## STAFF RECOMMENDATION Ransom Avenue/Byron Close Development 105, 108, 113, and 116 Ransom Avenue February 18, 2015

**Application:** New construction--infill

**District:** Elmington Place Neighborhood Conservation Zoning Overlay

**Description of Project:** The applicant is proposing to construct four of the eleven single family homes that are part of the Ransom Avenue/Byron Close SP development. The Commission approved the development plan in July 2012. Since that time, MHZC has approved the design of three of the houses, and one house has been constructed.

Figure 1. Site map.

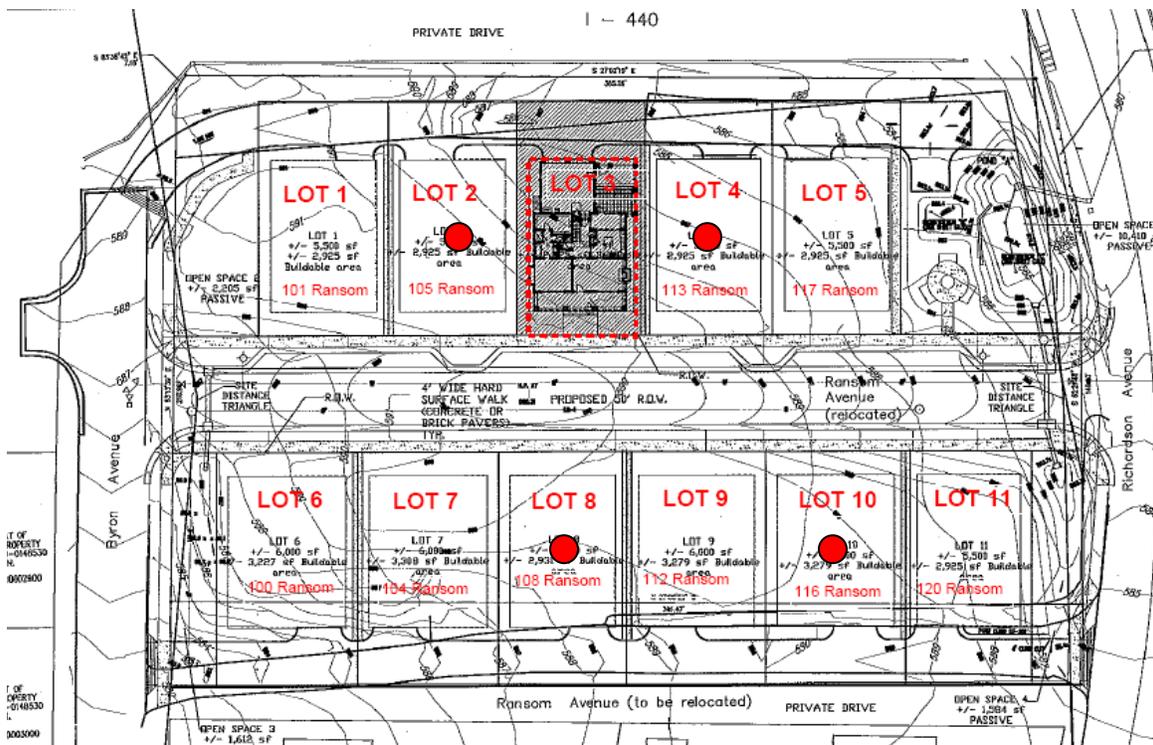
**Background:** Byron Close is an 11 unit residential SP development (BL2008-149) located on the previous site of Ransom School, close to I-440 and West End Avenue. The applicant now proposes design for infill construction of four of the eleven lots (Figure 1). The application is to construct new infill on Lots 2, 4, 8, and 10 (or 105, 113, 108, and 116 Ransom Avenue). The house on Lot 3 has already been approved and constructed. MHZC approved designs for houses on Lots 6 and 8 in 2014, but they have not been constructed. The design for Lot 8 that is part of this application is different than the design approved for the lot in 2014.
